## SERVICE BULLETIN

# Specification/change of engine configuration and/or type plate for ROTAX® Engine Type 912 and 914 (Series)

### MANDATORY

# Specification/change of engine configuration and/or type plate for ROTAX® Engine Type 912 and 914 (Series)

Fig. 1

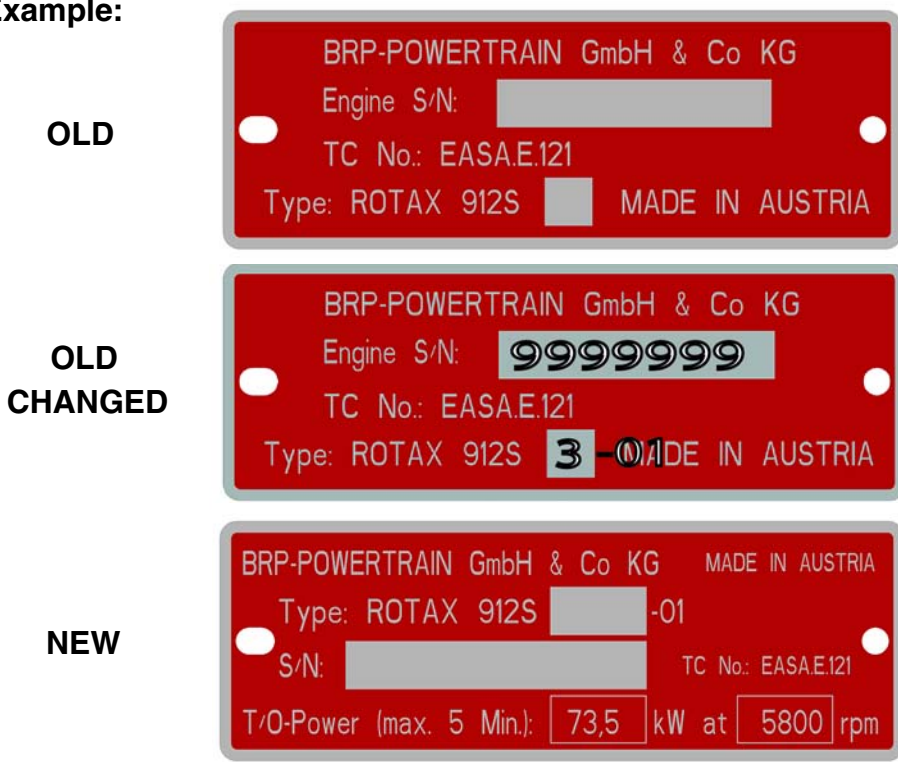
Suffix	Description	Note
-01	<p>New cylinder heads have been introduced for the ROTAX 912/914 engine Series in order to standardize the cylinder head raw part with the ROTAX 912 iSc Sport engine series. As a result the measurement position of the temperature sensor on the cylinder head has changed as well as the measurement medium (former aluminium, now coolant).</p> <p>As a consequence for all ROTAX 912/914 engines, the type designations of which are extended with suffix "-01", the engine temperature measurement methods have been amended from CHT (cylinder head temperature) and CT (coolant temperature) to only CT (coolant temperature). Therefore only the coolant temperature limit applies.</p> <p>Example for identification: "ROTAX 912 S3-01"</p>	<p>Engines from serial number 912 A: 4 411 087 912 F: 4 413 045 912 S: 4 924 911 914 F: 4 421 445 are already equipped with a new type plate with suffix, which has been extended by some more information (see Fig. 1).</p>

The following suffix may only be added to indicate configuration changes / modifications / overhauls. The remaining content of the type plate must not be changed.

Step	Procedure
1	Apply suffix - 01 permanently (e.g. engraved, stamped or similar) to the type plate. NOTE: Any changes regarding to this Service Bulletin must be confirmed in the engine logbook.
